Commission Agenda Report

Planning Commission Meeting
06-18-26
Item 4.A.

Subject: Coastal Development Permit No. 18-029 – A follow-up application to Emergency Coastal Development Permit No. 18-002 for the removal of temporary slope protection measures and the construction of permanent slope protection measures consisting of two revetments on the ocean side of a private street (Continued from May 18, 2026)

Locations: 31618 Sea Level Drive, within the appealable coastal zone
APNs: 4470-017-009; 4470-001-014 through 4470-001-026
Owners: Malibu Encinal Homeowners Association (MEHOA); WHE Properties, LLC; Gary and Daphne Murphy; X17 Inc; Sea Level Properties II, LLC; Elizabeth E Heitman Trust; Drake Family Trust; Steve Shuken Trust; MH and JM Gainer Trust; CWMBS, Inc.; Fusco Family Trust; Steve Supowitz; Fusco Family Trust; Crowley and Summers; P and C Partners LP; BJGL Holdings I LLC

DRAWN	
CHECKED	
DATE	06/06/18
SCALE	
JOB NO.	
SHEET	S1
OF	7 SHEETS

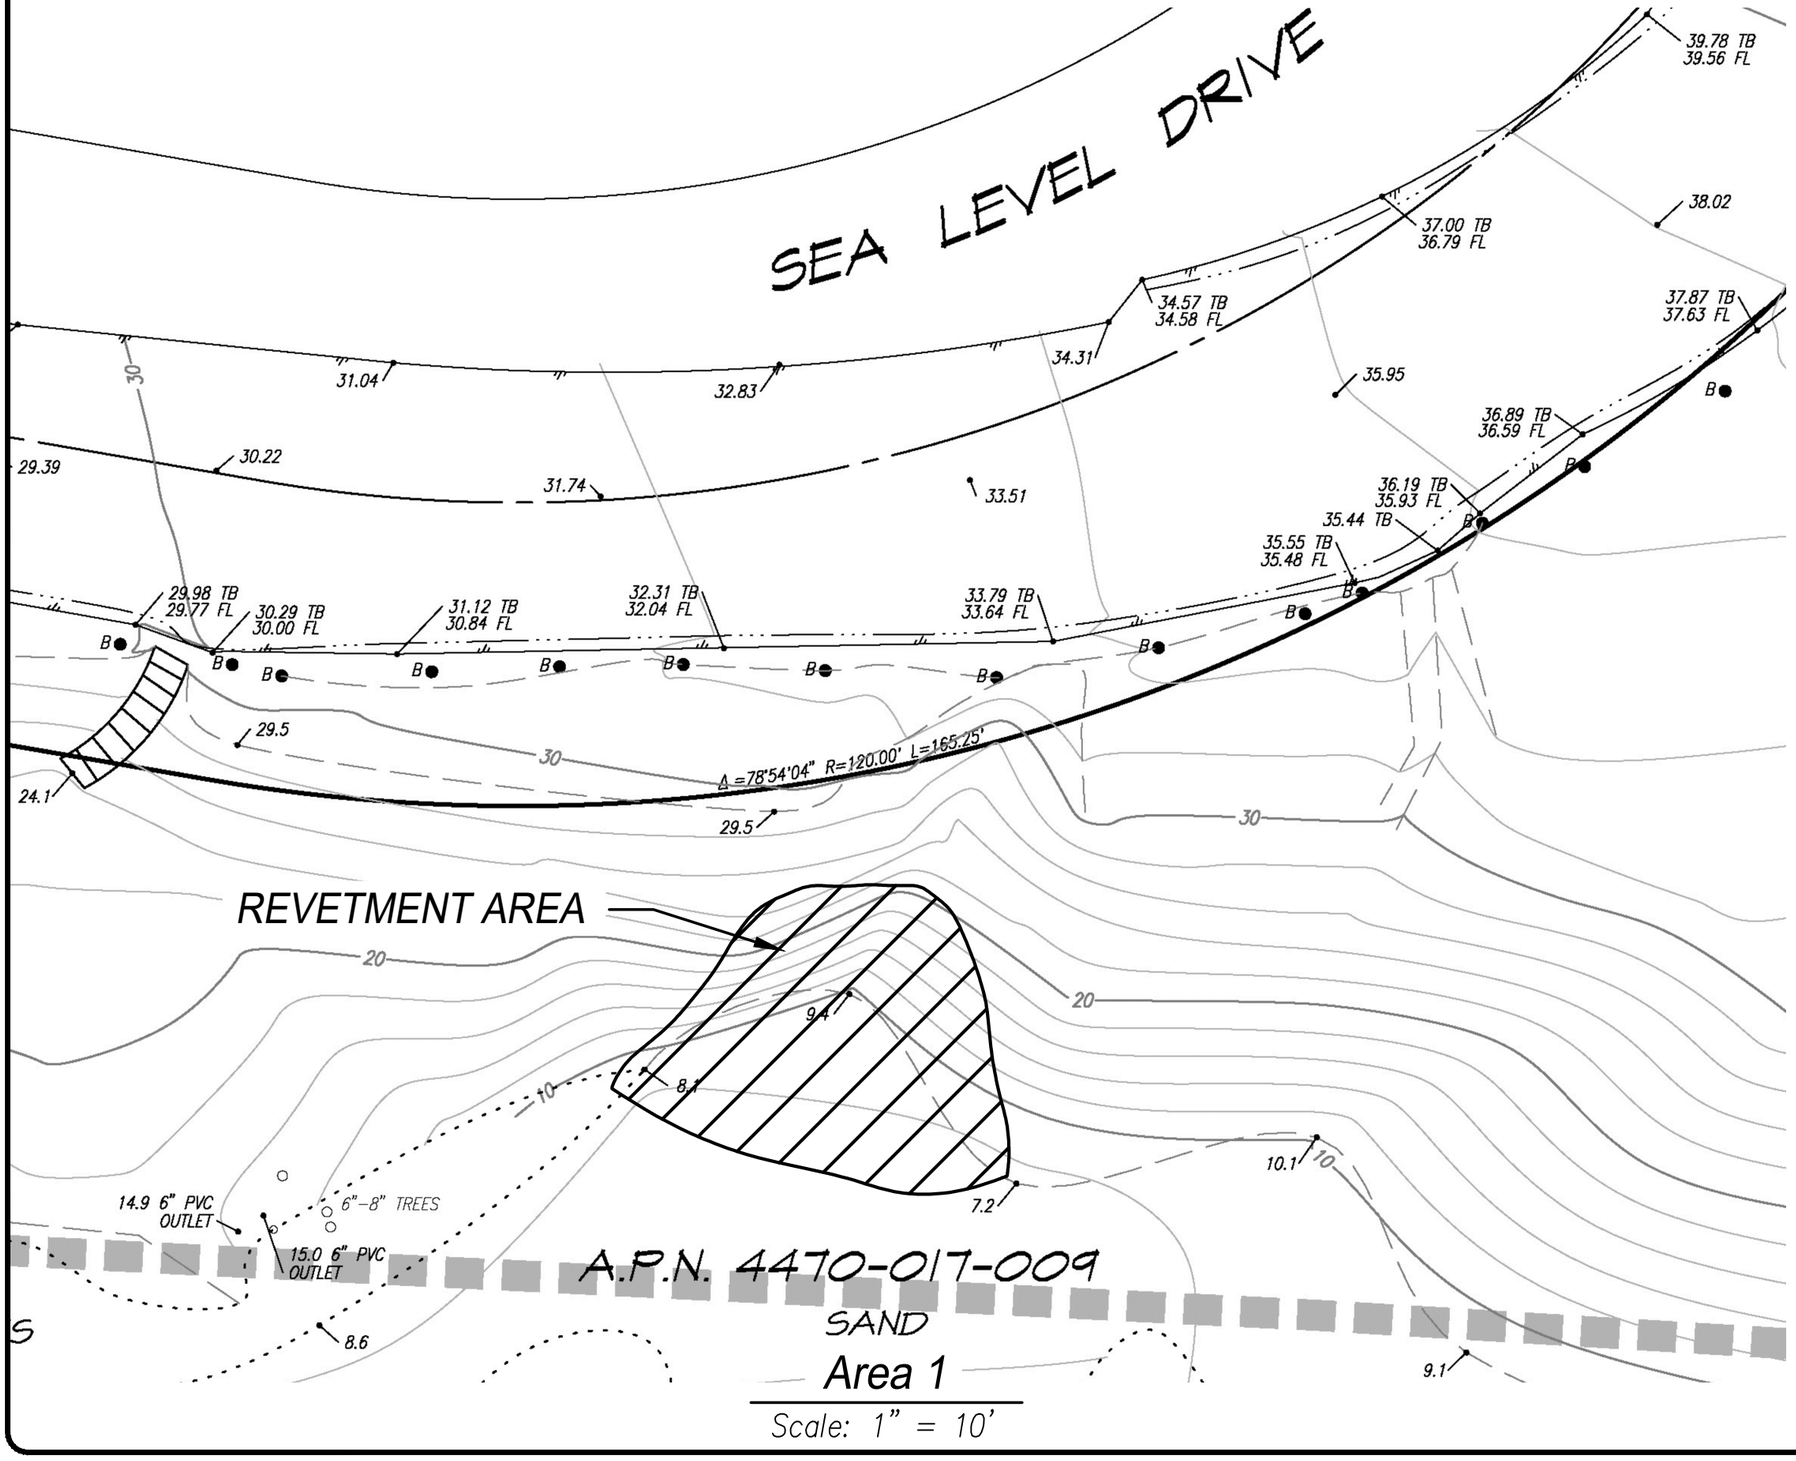
1. Please show Cross-Section X-X' on the site plan, Sheet S1 of the plans.
